ADDENDUM NO. 03

Project: Wastewater Treatment Facility Improvements
Walnut Ridge, Arkansas

The Contract Documents dated February 3, 2021, are hereby amended as follows:

Wastewater Treatment Facility Improvements

JOB NO.	CRI-013
SHEET NO.	E3

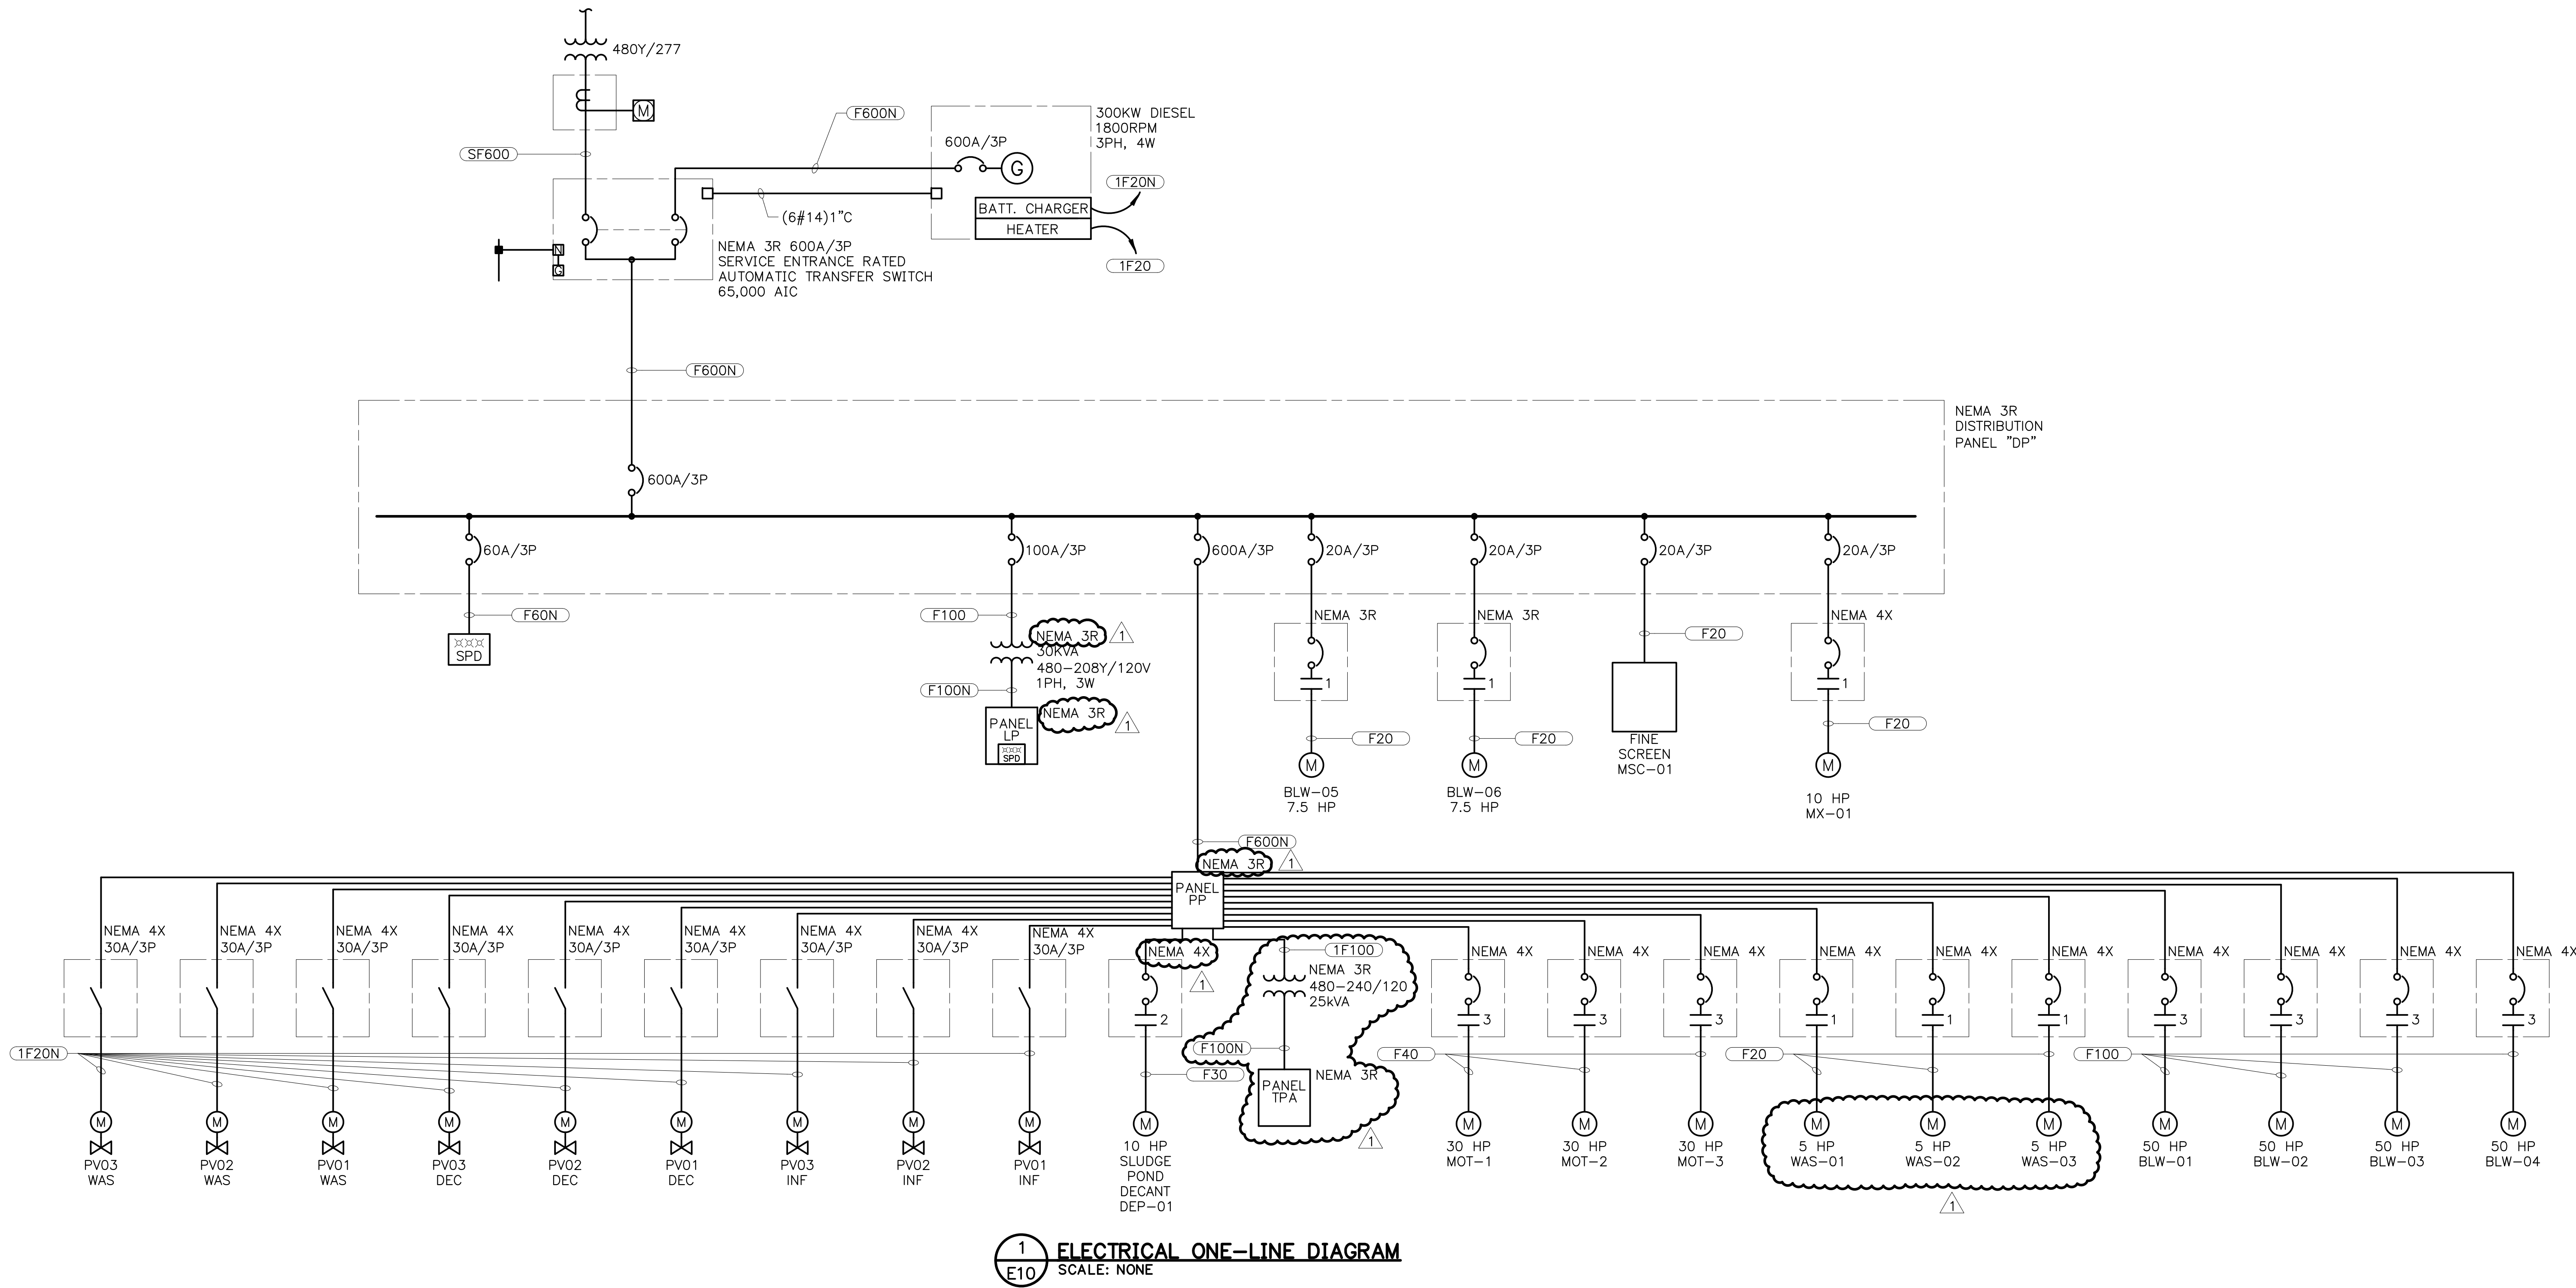
22. Drawing E-3 – Electrical Lighting Plan:

- a. Modify this drawing as shown on the Addendum No. 3 – Electrical Lighting Plan, attached hereto.
